Evaluation of the Storms Pool Improved Waterflood Project

Topical Report

**By
Douglass K. Norton
Dwight L. Dauben**

**Prepared by
Keplinger Technology Consultants, Inc.
6849 E. 13th St.
Tulsa, OK 74112**

MOVABLE OIL SATURATION
(WELL NO. 10-5, DUAL INDUCTION LOGS)

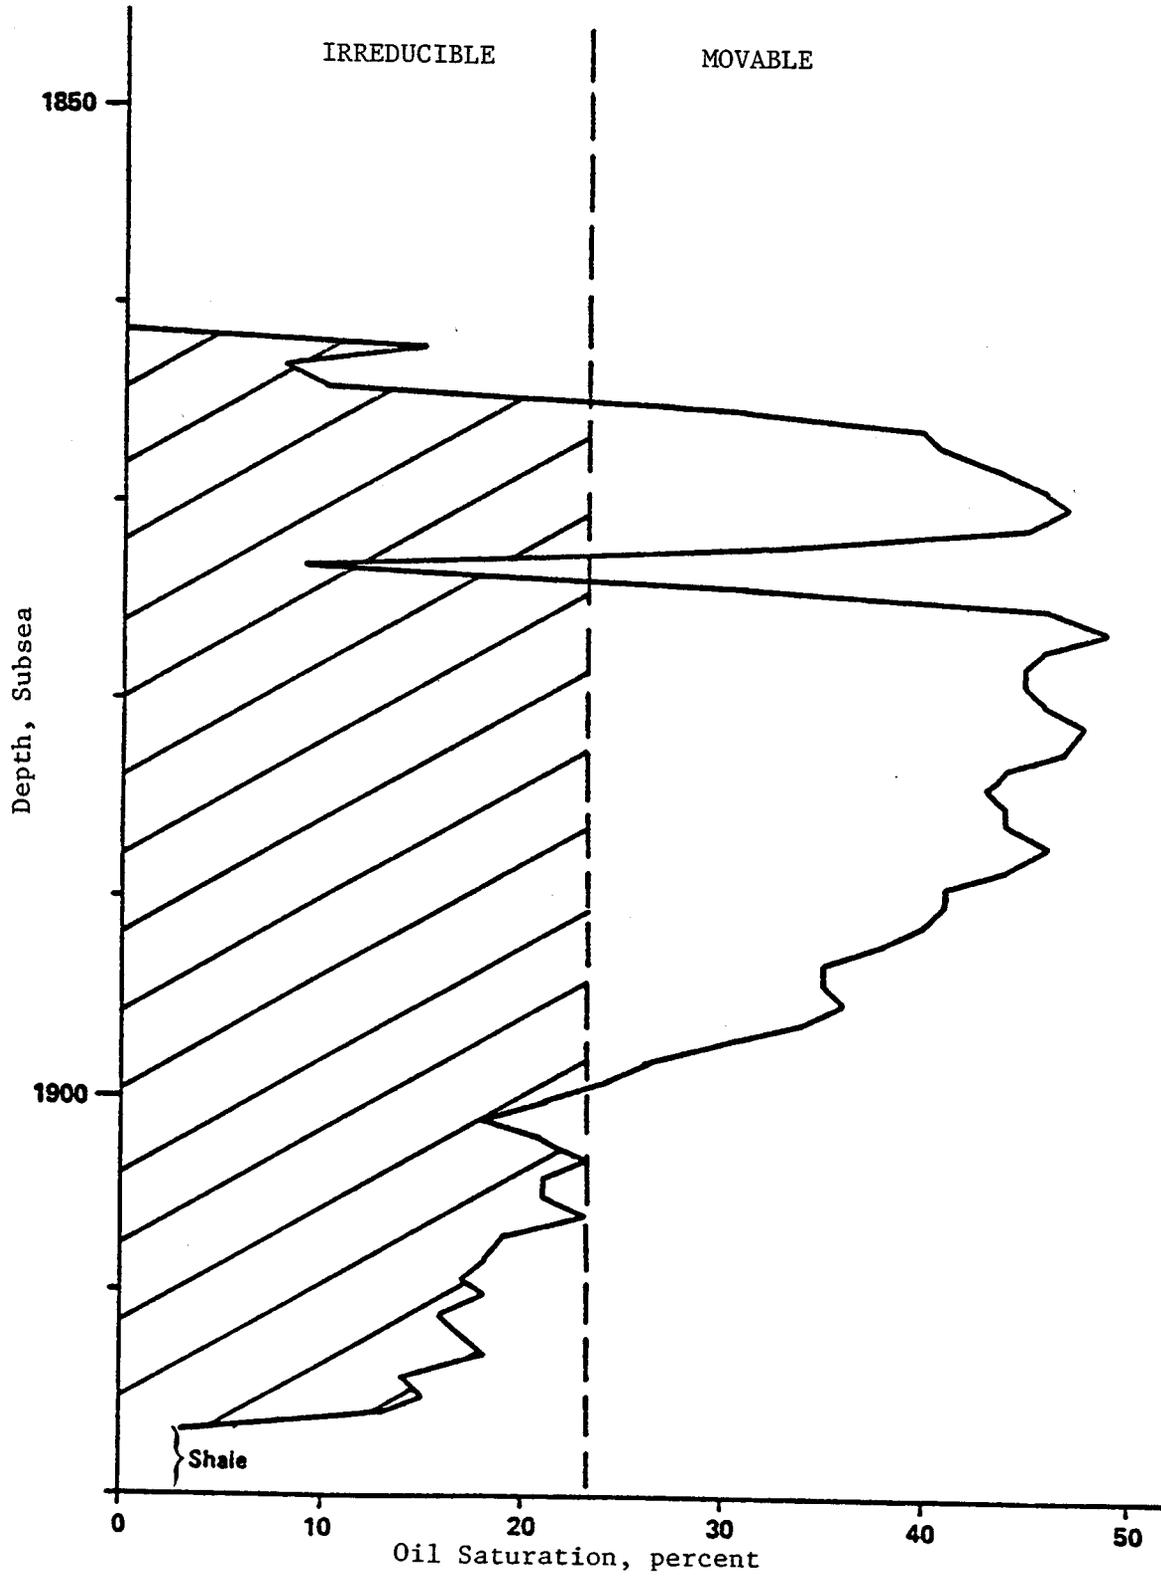
We believe that a 17 percent movable oil saturation is high. First, there are uncertainties in the 40 percent oil saturation due to the known inaccuracies of using well logs for measuring intermediate-range oil saturations. Questions also exist on the saturations from volumetric estimates, due to the compounding of errors in the basic measurements which leads to a final computation, and to the uncertainties in the areal and vertical distribution of the oil. Second, and more important, we believe that the residual oil saturation as determined by the core analysis was too low. Oil is normally

STEADY-STATE WATER-OIL RELATIVE PERMEABILITIES

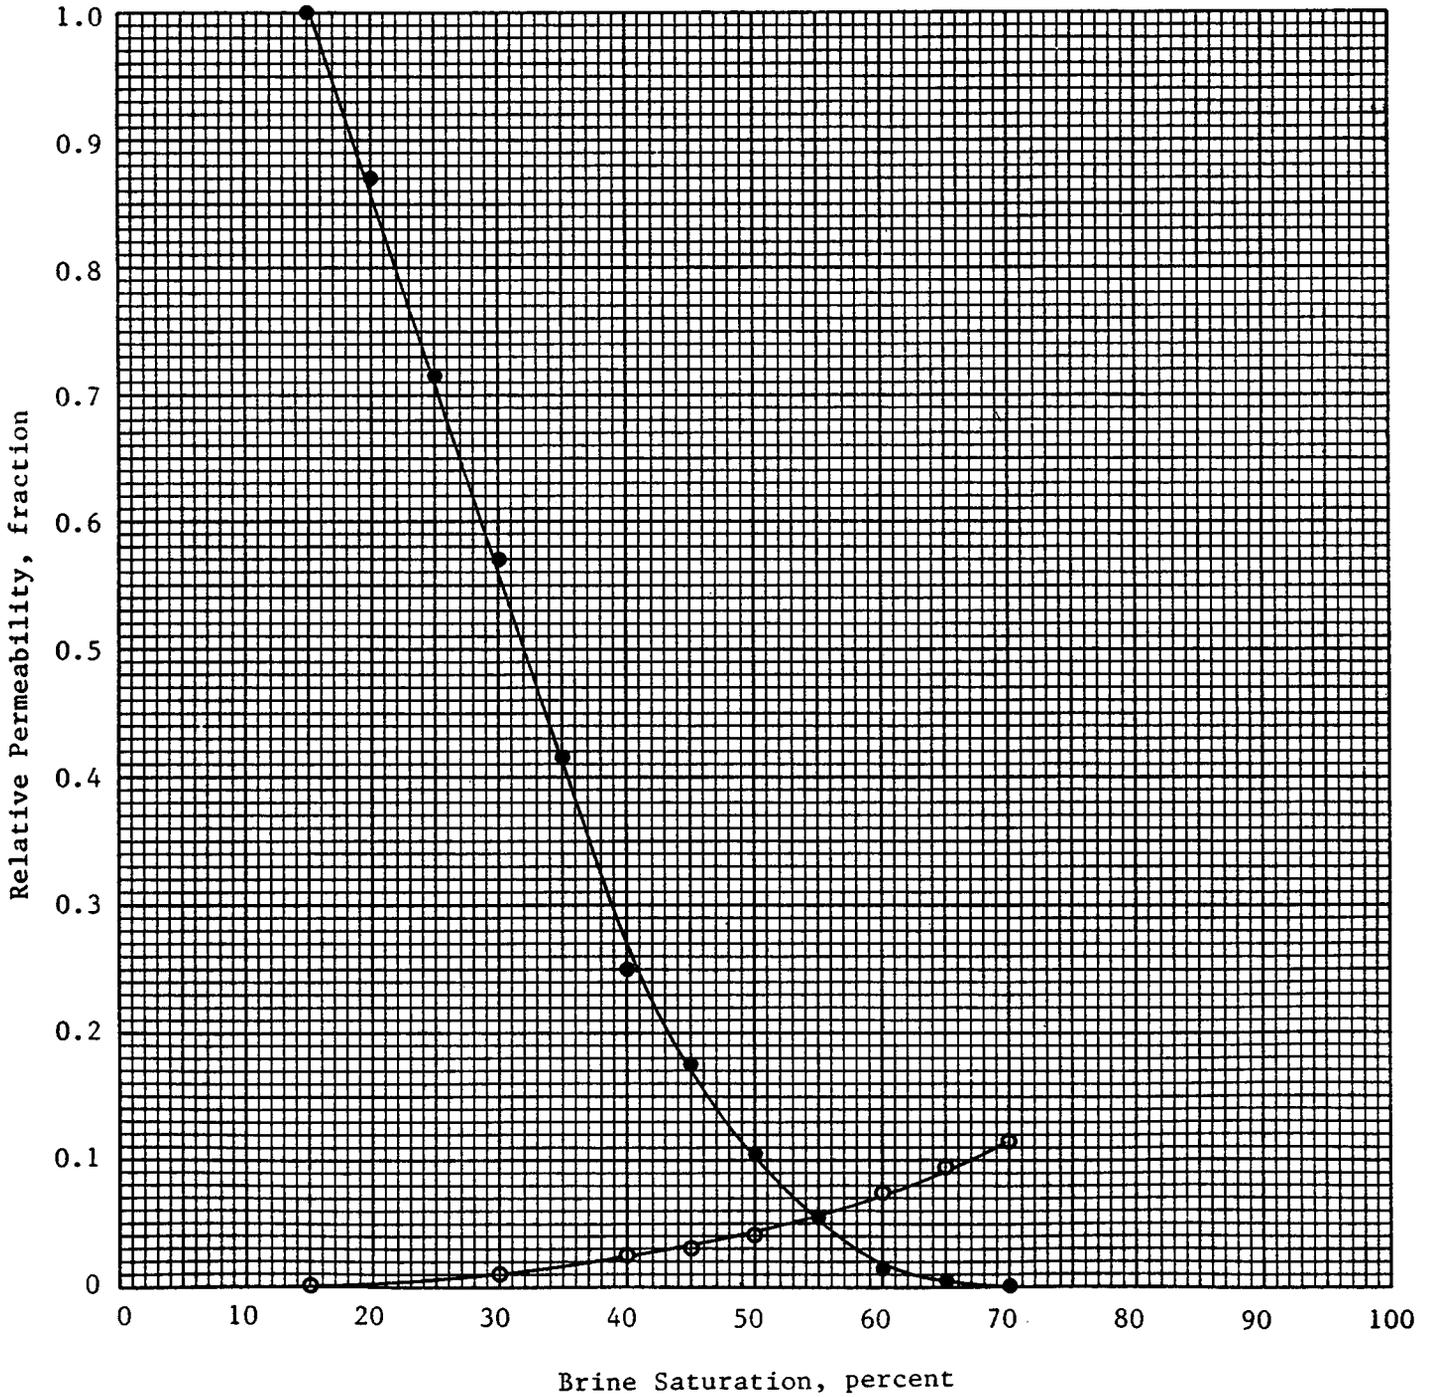
The mobility ratio was computed using Figure 5 (steady-state test) and the definition of mobility ratio which is consistent with the correlation shown in Figure 13. It is defined as:

$$M = \frac{.11}{1} \cdot \frac{6}{1} = .66$$

LOCATIONS OF SAMPLING STATIONS AT STORMS POOL UNIT

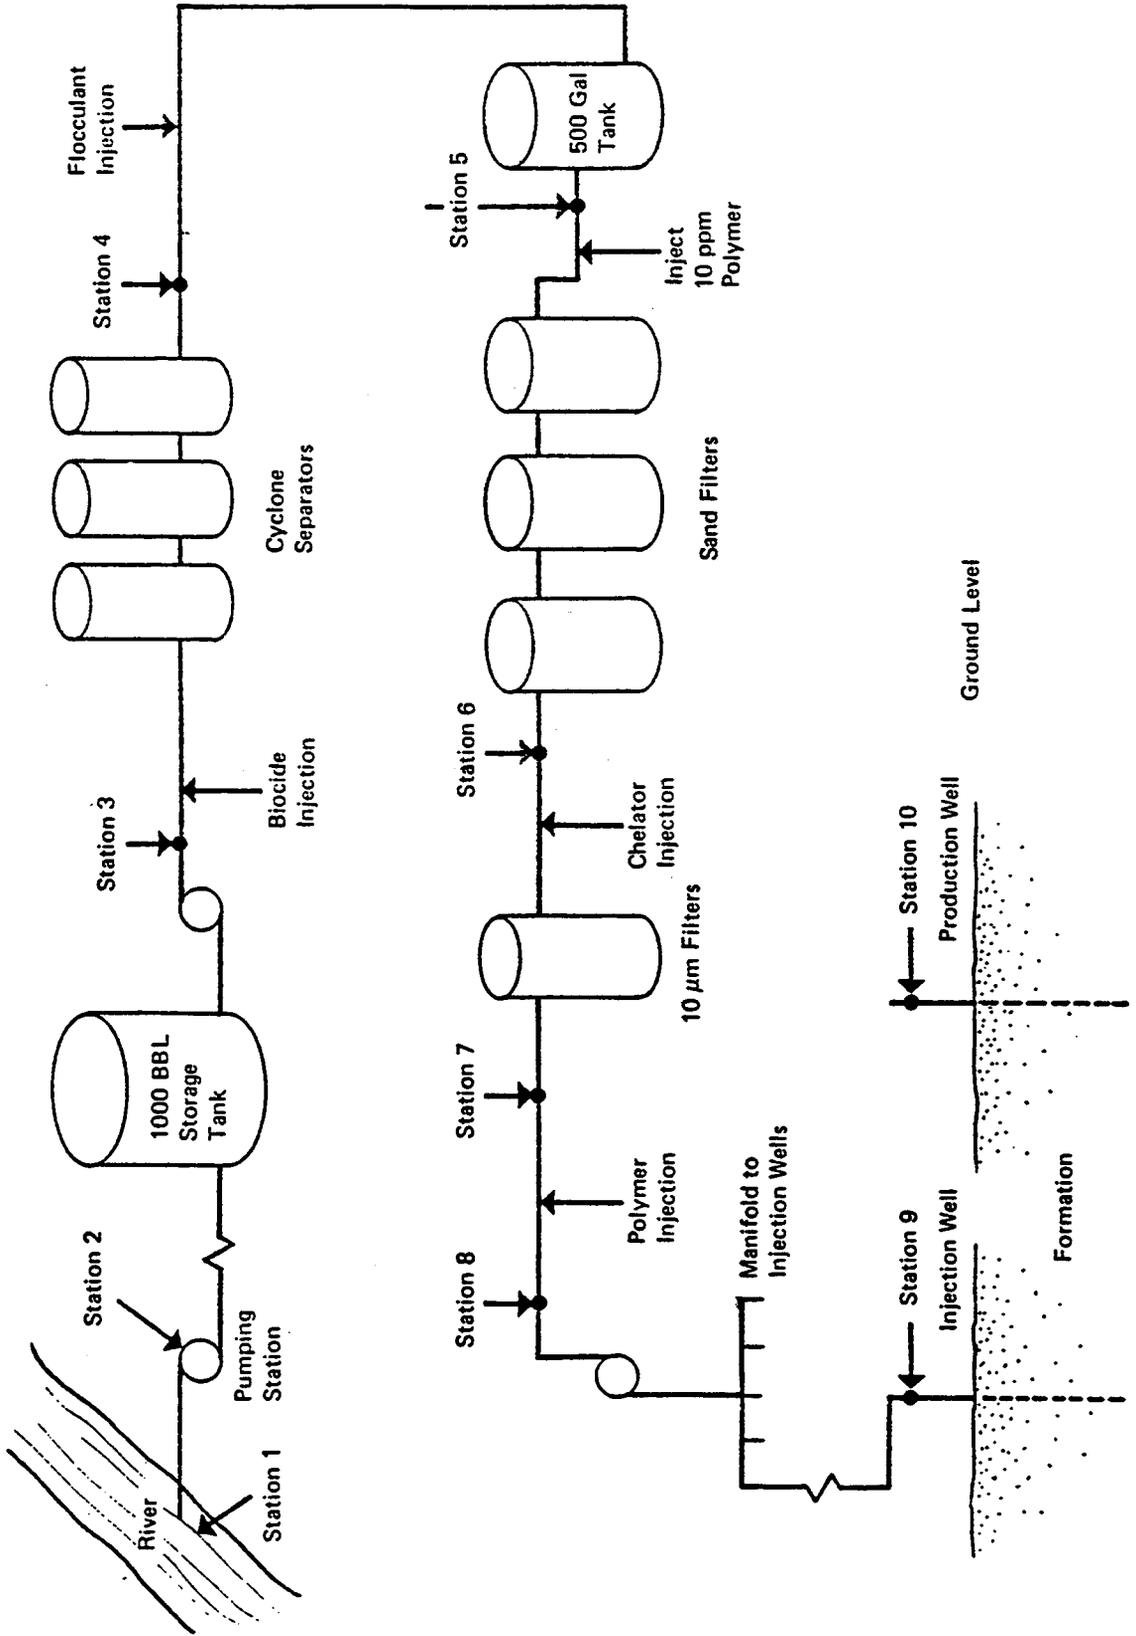
The selection of the river water can be questioned. As earlier indicated, river water inherently introduces problems related to the bacteria, entrained oxygen, and solids content. It has some advantages arising from the low salinity. However, the biopolymer can perform acceptably well at the salinity level of the produced water (38,000 ppm). The produced water would have advantages in having reduced solids content, significantly less oxygen, and reduced biodegradation problems. The concentration of the polymer would have to be increased somewhat to compensate for the increased salinity. A further alternative would be use of fresh water from shallow zones within the area. This area is known to contain an ample supply of fresh water in various shallow zones.

Filtration could have been improved by the use of diatomaceous earth filtration. This type of system is very effective in the removal of

OIL PRODUCTION HISTORY
STORMS POOL IMPROVED WATERFLOOD

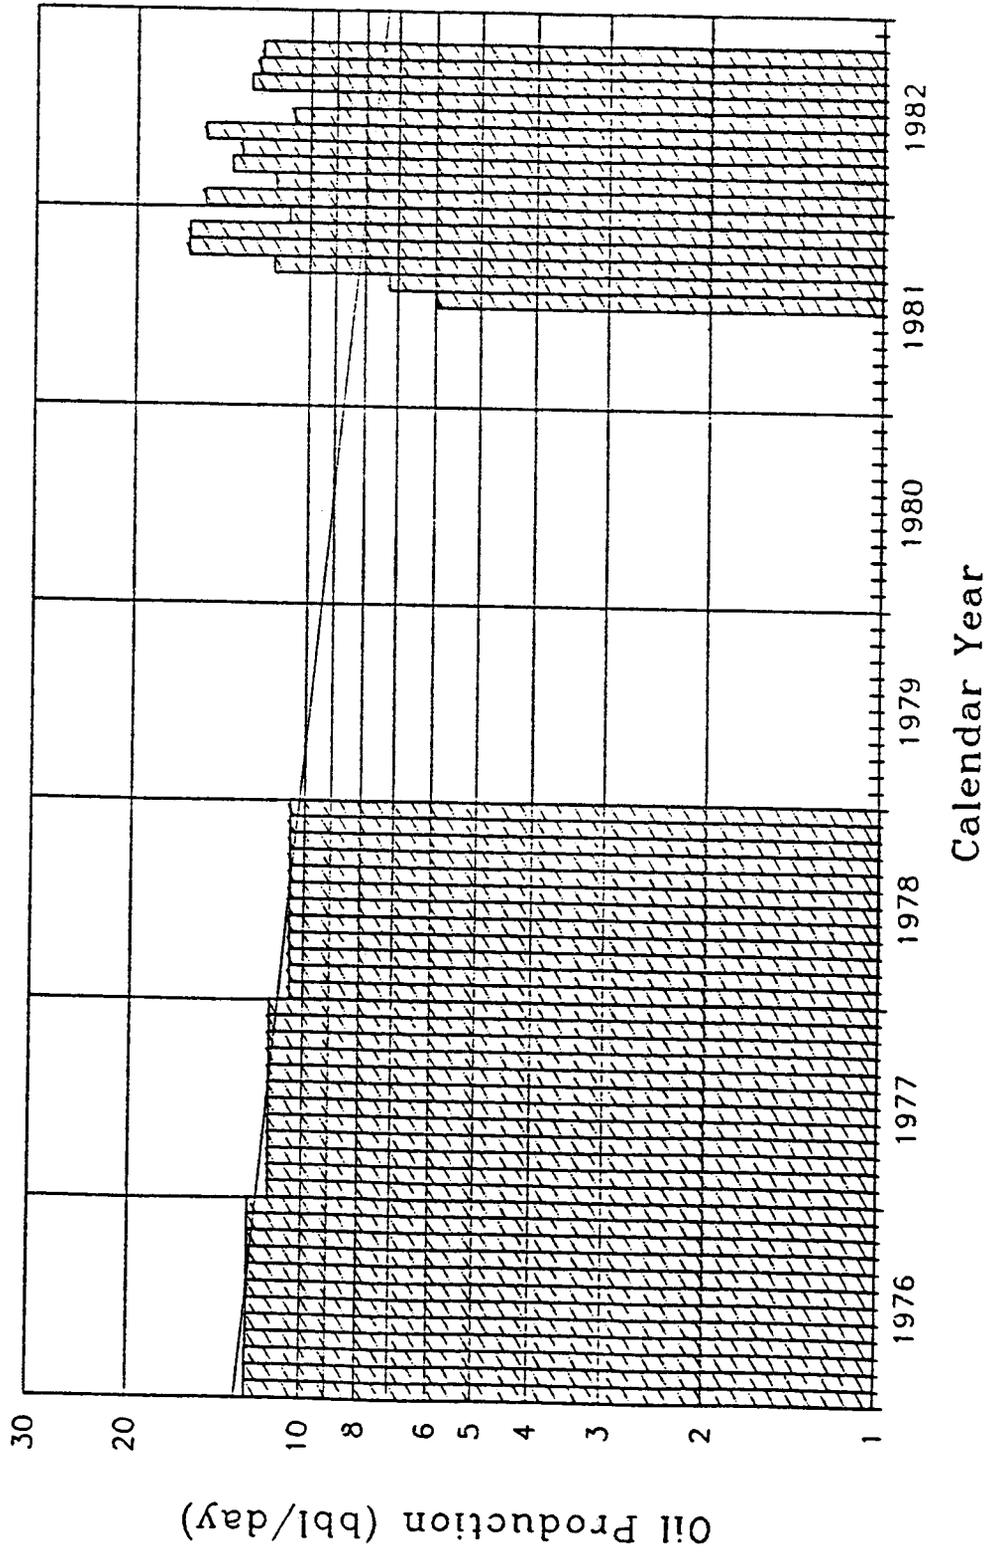
Oil production associated with the injection period is plotted in Figure 12. Neither producing water cut information nor total withdrawal rates from the pilot area were published in the annual reports, so it is not known whether the increase in average daily production from a total of 7.8 barrels of oil per day to about 12 barrels of oil per day was due to polymer injection or to other factors such as workovers, injection rates, or withdrawal rates. This oil production increase, even if entirely due to polymer injection, can only be considered meager, both from a technical and an economic viewpoint.
